HIGHLAND CITY DEVELOPMENT ADMINISTRATION BOARD AGENDA

DEVELOPMENT ADMINISTRATION BOARD AGENDA REPORT ITEM #2

DATE: April 11, 2024
TO: Development Administration Board
FROM: Rob Patterson, City Attorney / Planning & Zoning Administrator
SUBJECT: **Final Plat Approval:** Foxwood Estates
TYPE: **LAND USE (ADMINISTRATIVE)**

Foxwood Estates Subdivision

Sheet No.
P - 7

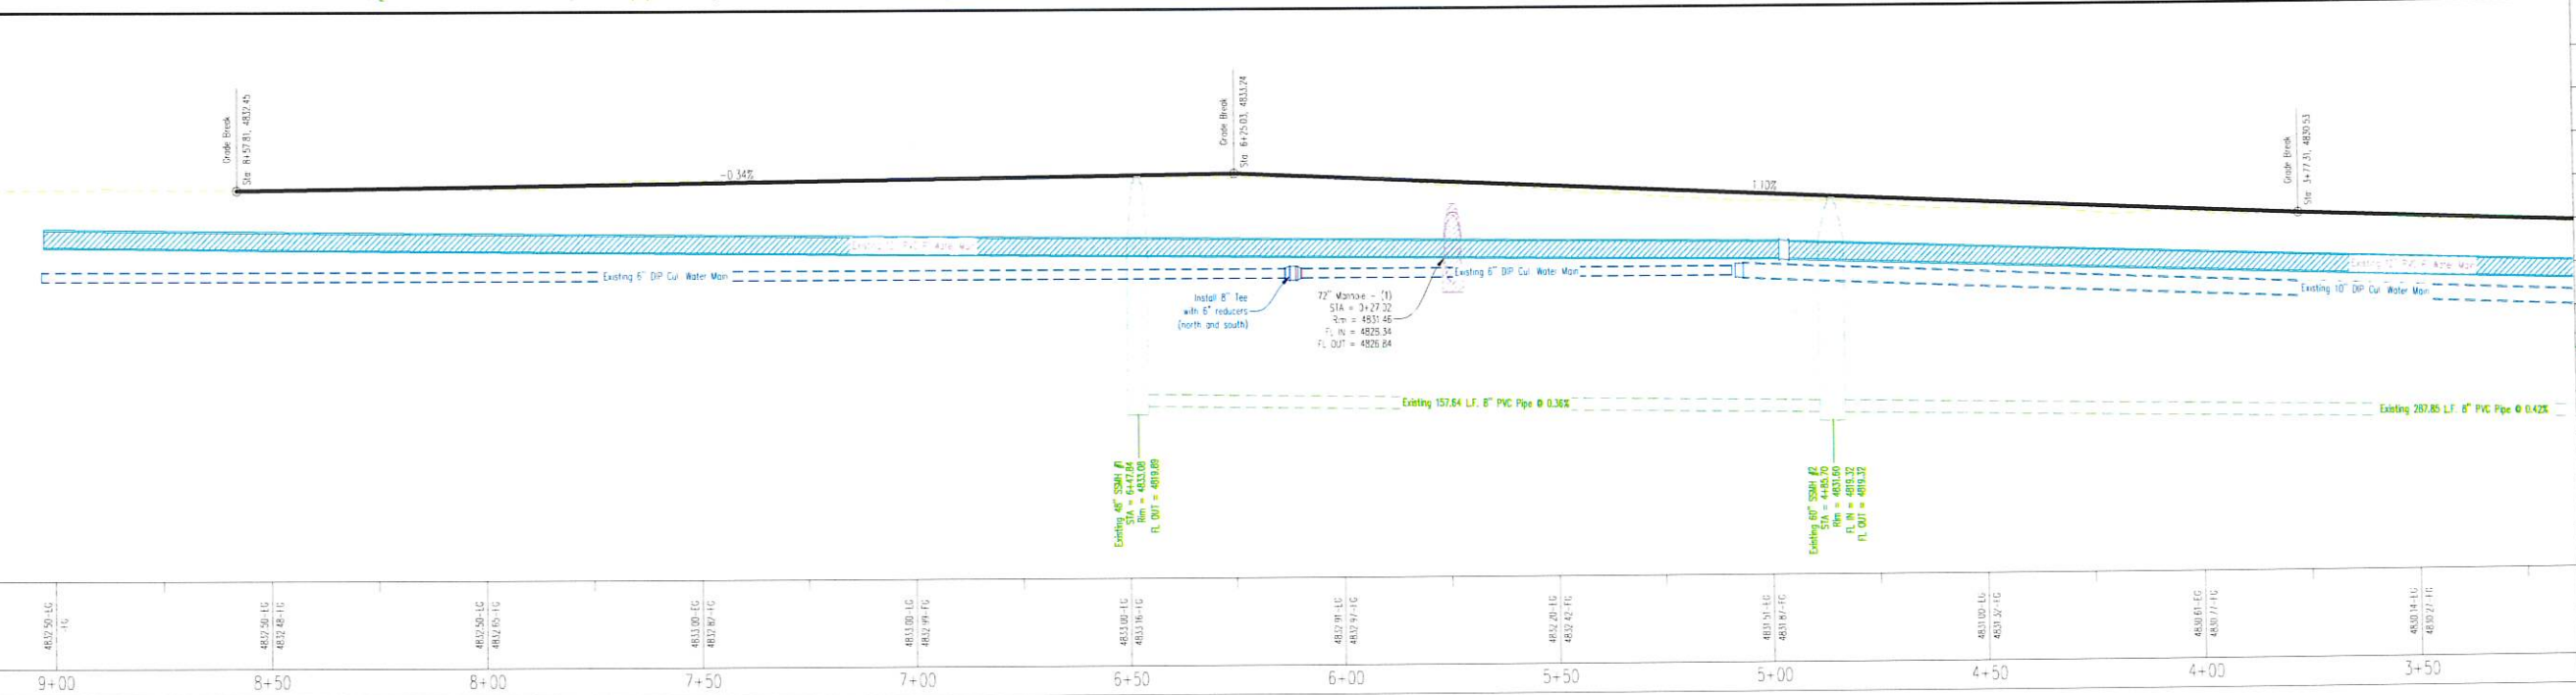
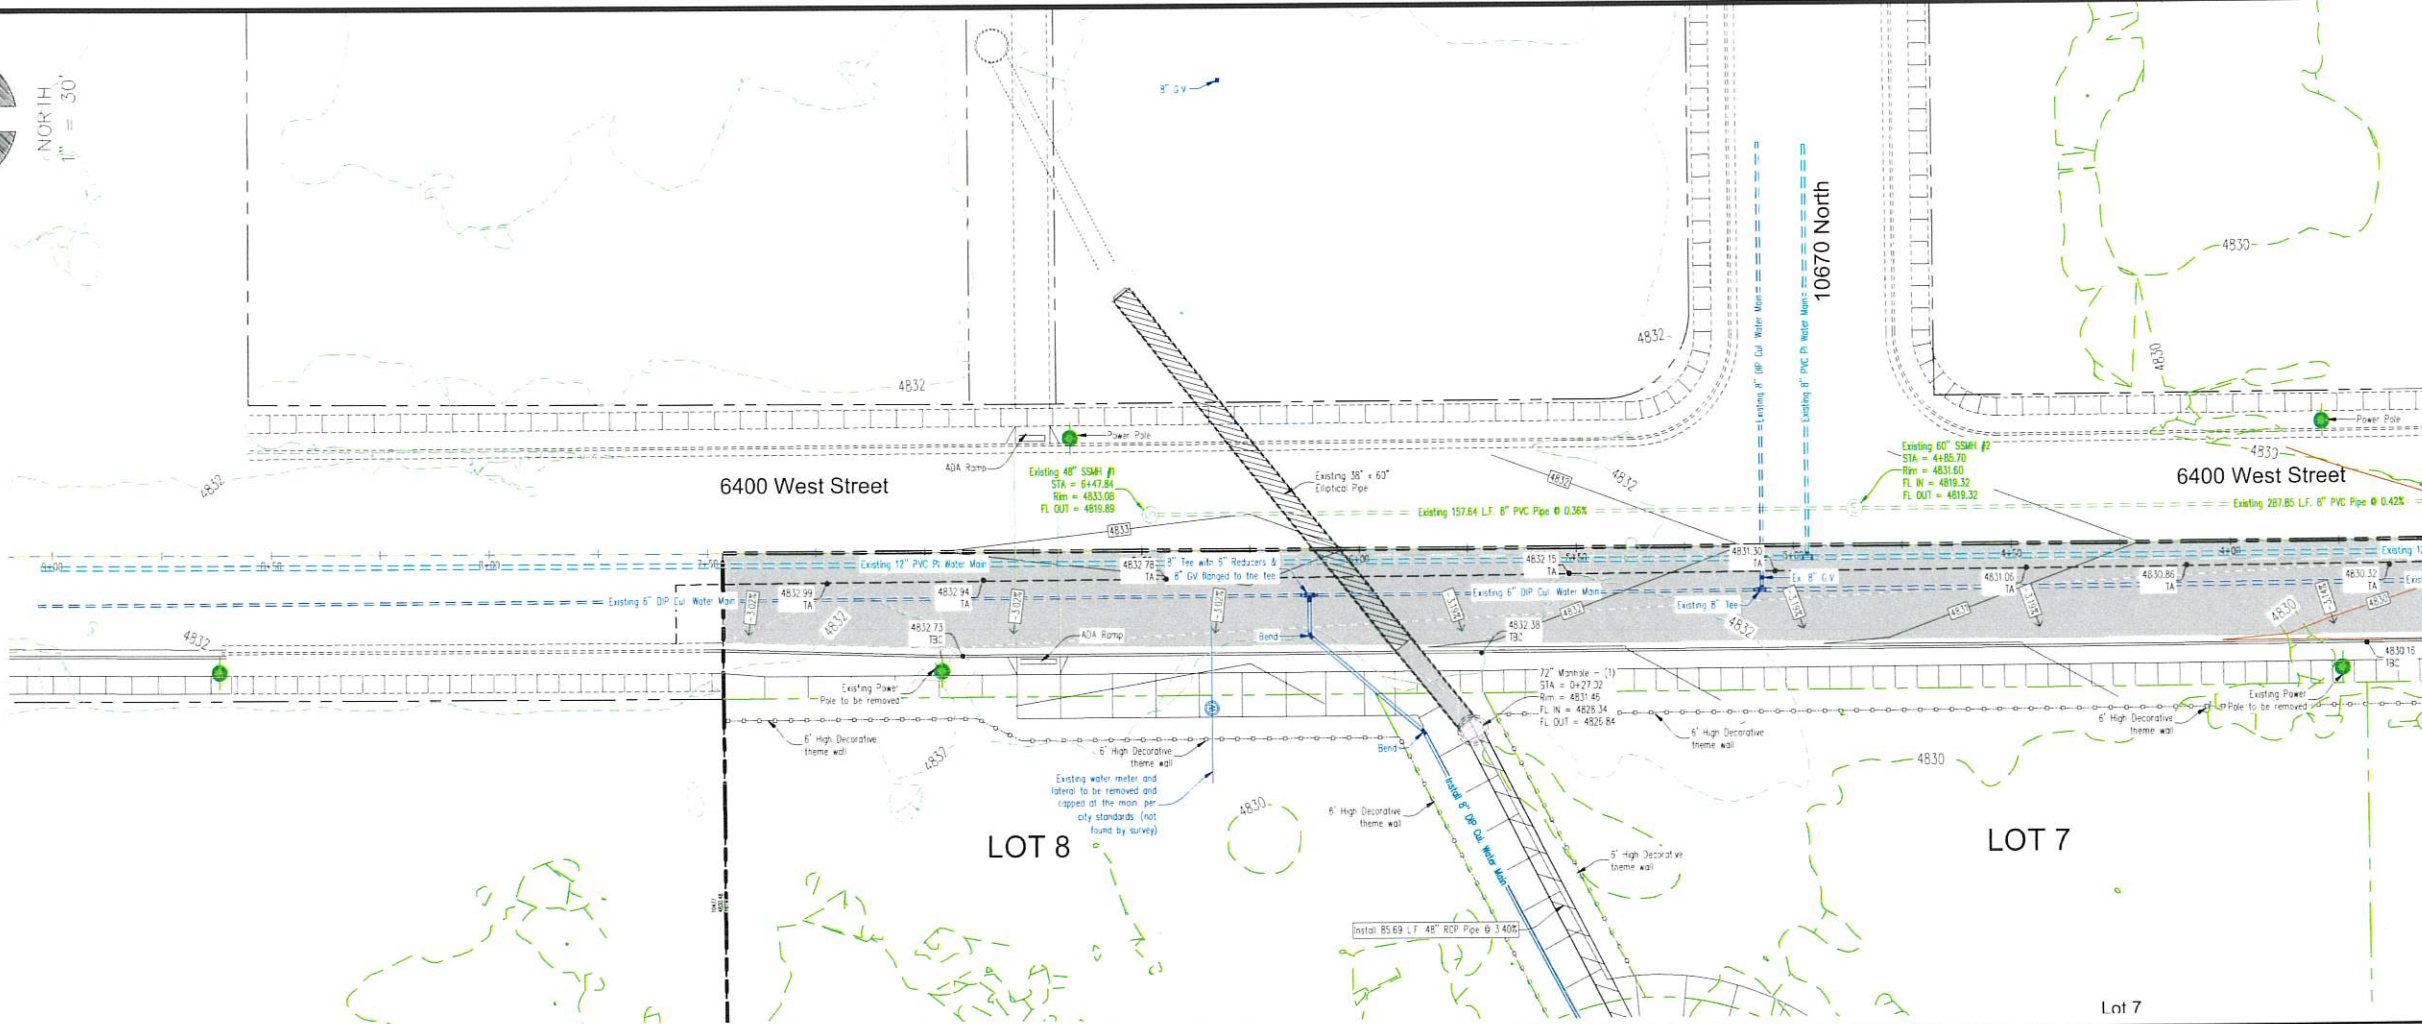
Sheet P-7:

Sheet No.
P - 9

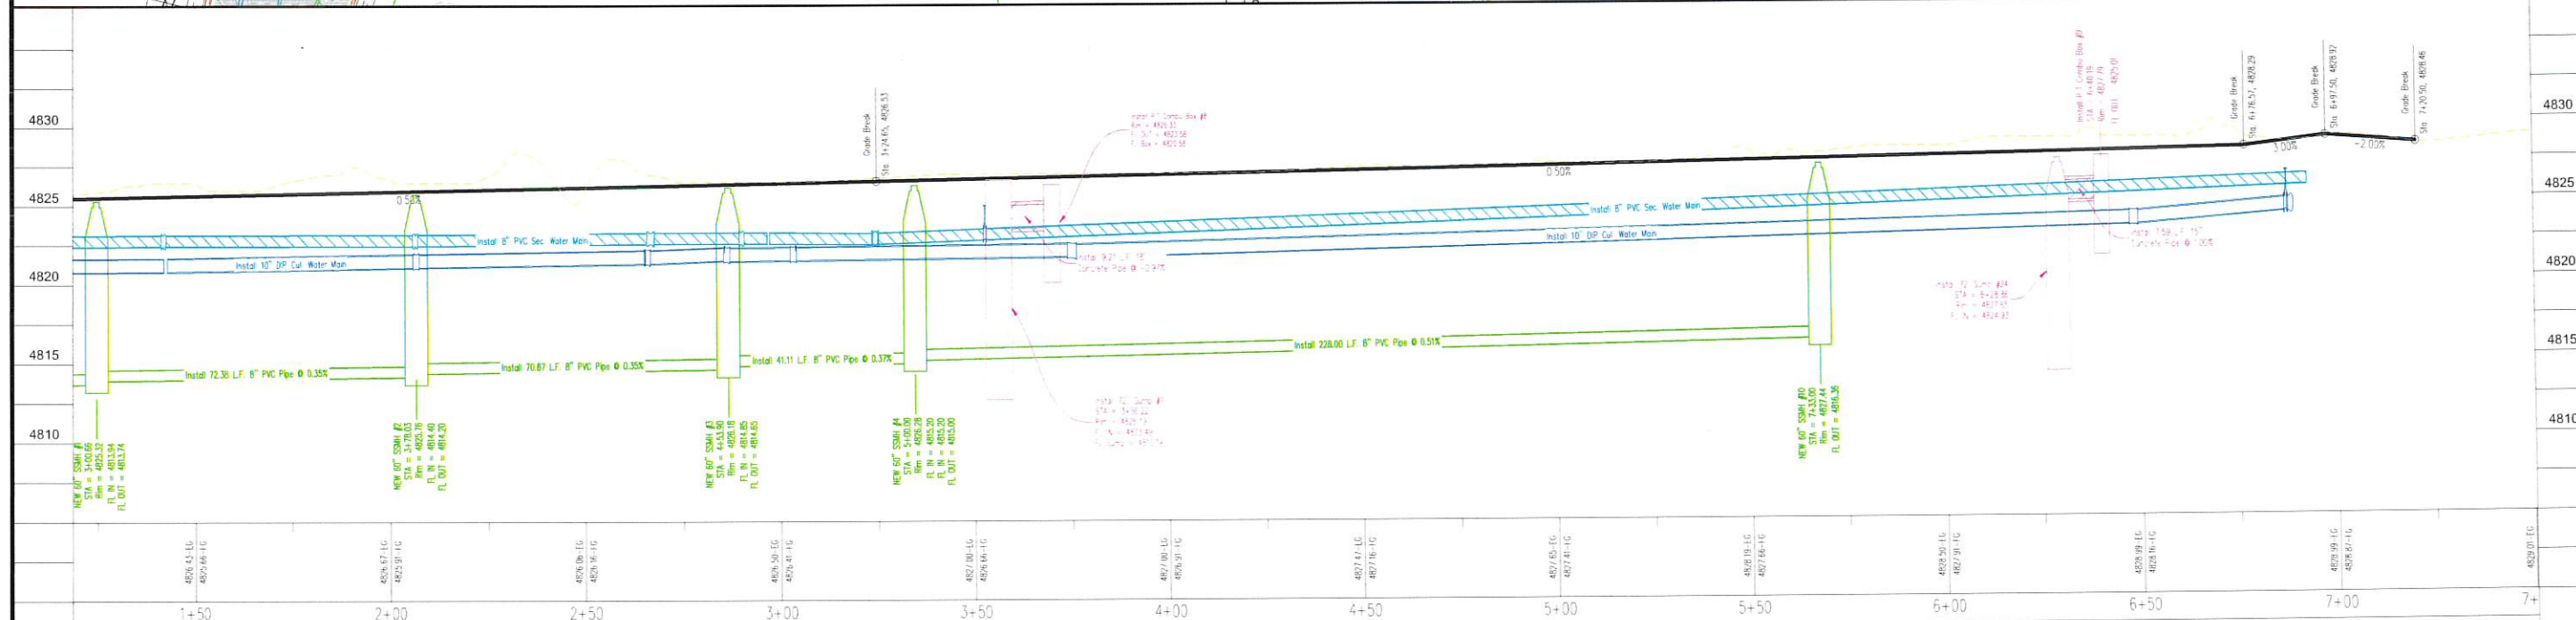
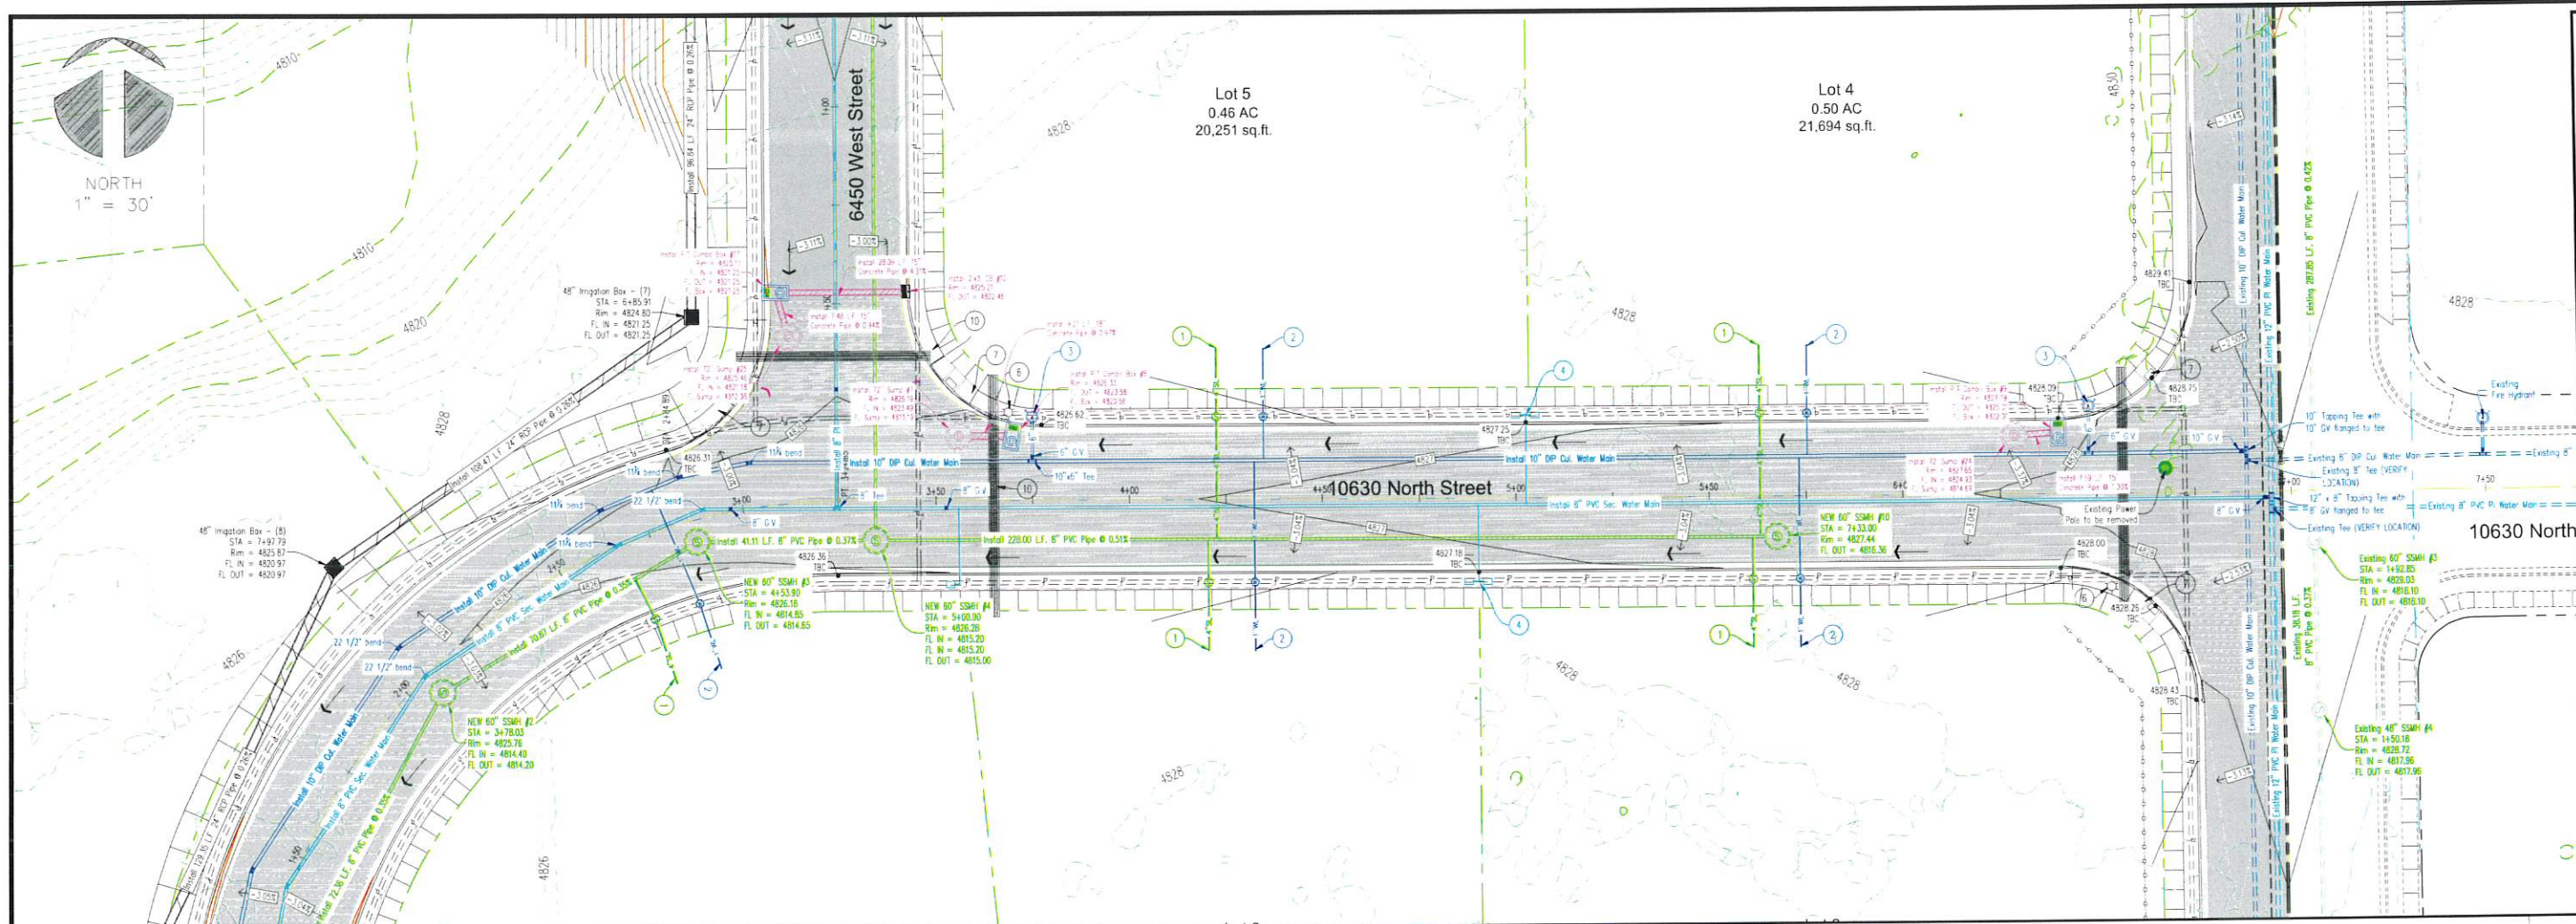
- 69. Follow Standard Detail SS-04 for SSMH sizing these are all labeled 48" not 60".
 - a. Response: All have now been changed to 60".
 - b. Reply: This comment is closed
- 70. Culinary Pipe type in notes all need to be DIP per DW-04.
 - a. Response: Revised.
 - b. Reply: This comment is closed
